Staff Report to the Zoning Administrator

Application Number: **05-0620**

Project Description: Proposal to construct a two-story single-family dwelling.

Environmental Planning Completeness Comments

SHEET
G-1

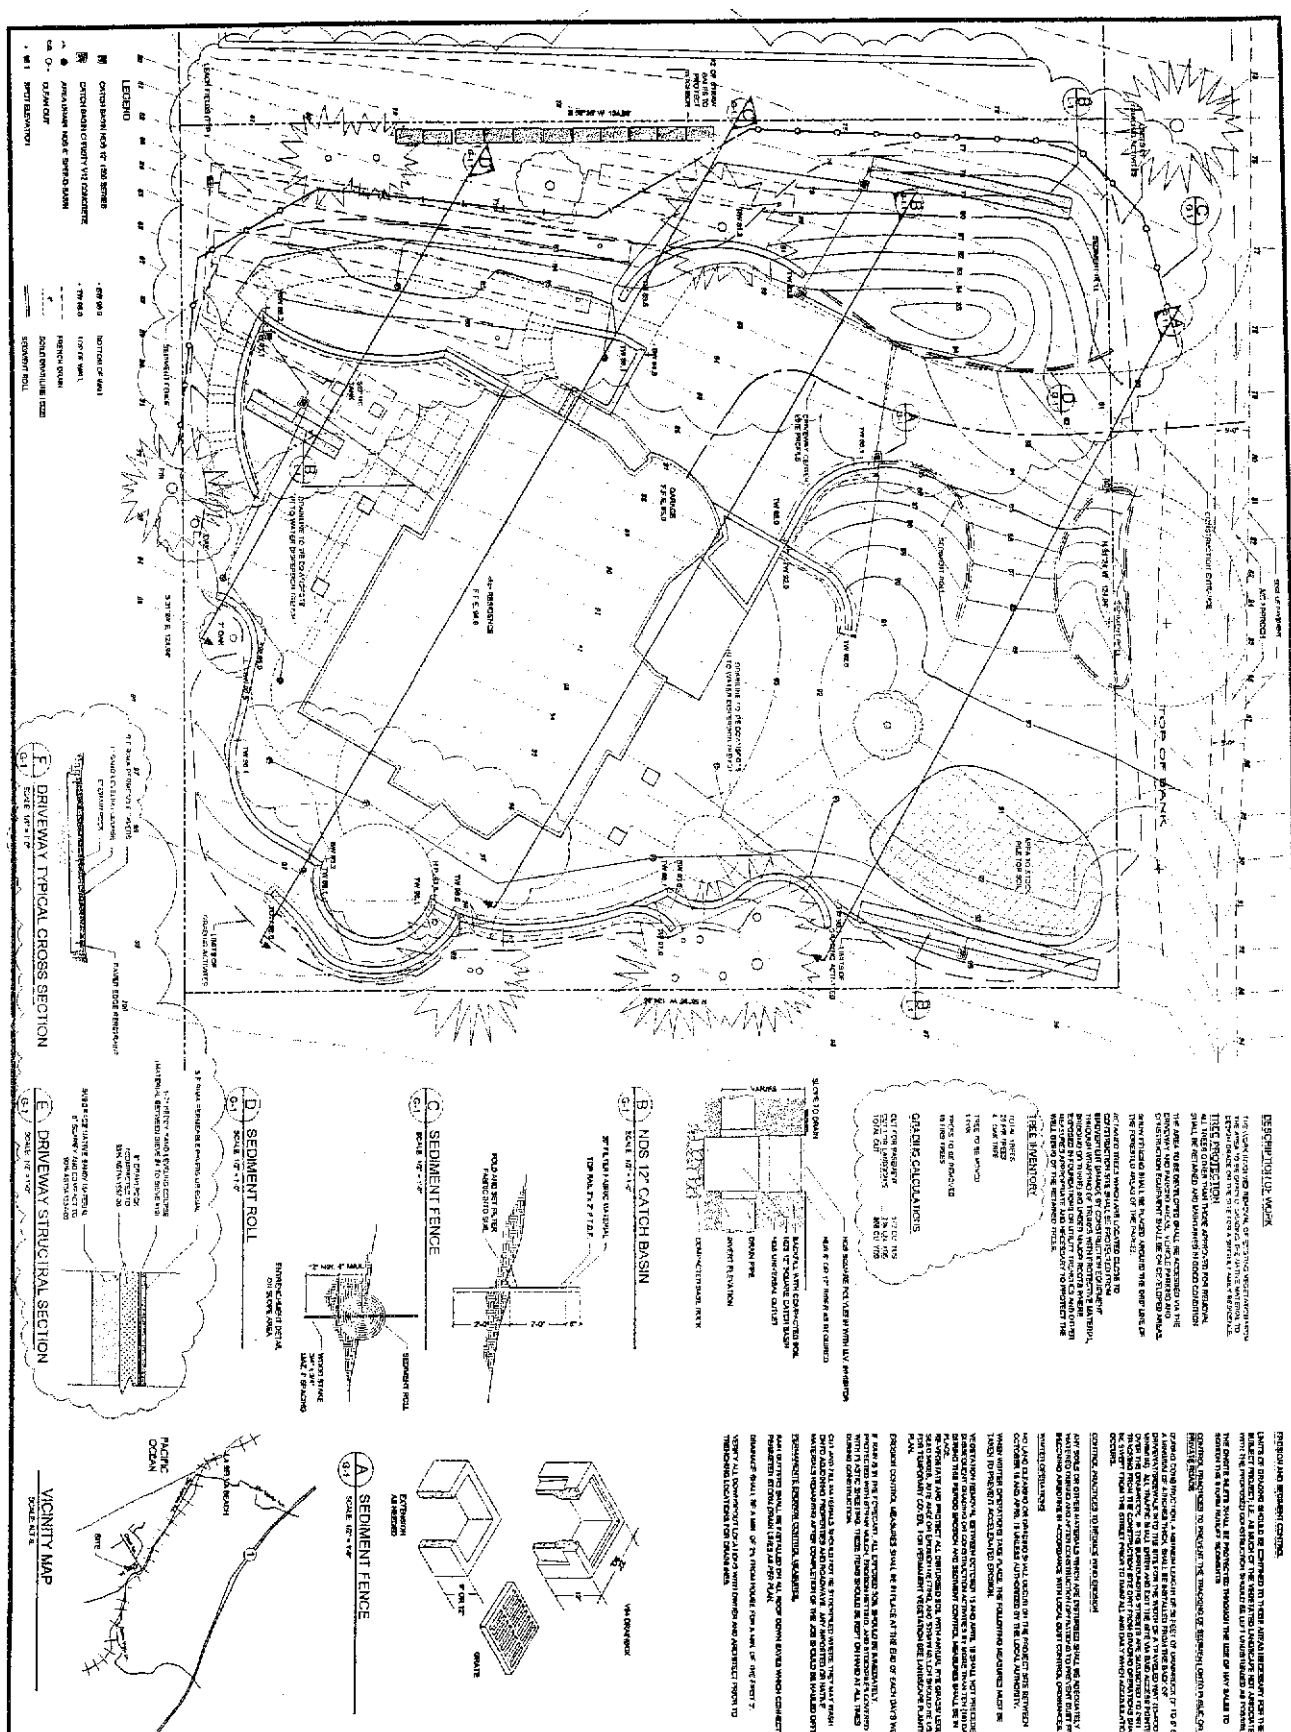
1. Please provide the four grading cross-sections identified on Sheet G-1.
2. Please separate out the grading quantities: Indicate the quantities for the base-ment (which is exempt from grading ordinance). the remainder of the grading for the residence, site work, and overexcavation / recompaction.

4. The north property line area contains numerous trees. If these trees are on this property please identify. The plan (Sheet G-1) currently states that the area is covered in brush. NOTE: Some trees may be allowed to be removed but that those removed will need to be replaced with new trees (coast live oaks, monterey cypress).

===== UPDATED ON OCTOBER 12, 2005 BY KENT M EDLER ===== 1. Show the septic system on the grading plans. Please note that Env. Health generally does not allow-ing gradin gin the area of septic systems, so the grading in this area will most likely need to be eliminated.

2. Fill slopes are shown on the plans as steeper than 2:1 in some locations. This is not acceptable per County Code. Revise plans accordingly.
3. Grading should be revised so as not to conflict with the trees to remain per Bob Loveland's comments.
4. The soils report has been accepted
5. The dispersion trench northwest of the residence is located above a fill slope and should be relocated away from the fill slope.
6. Show finished pad elevations on sheet G-1.

C) Detail A, sheet G-1 is mislabeled

I) Incomplete. Detail A, sheet G-1 is still mislabeled. The catch basin is titled as a sediment fence. The notation as a V64 drainbox does not agree with the legend for a V12 catch basin.
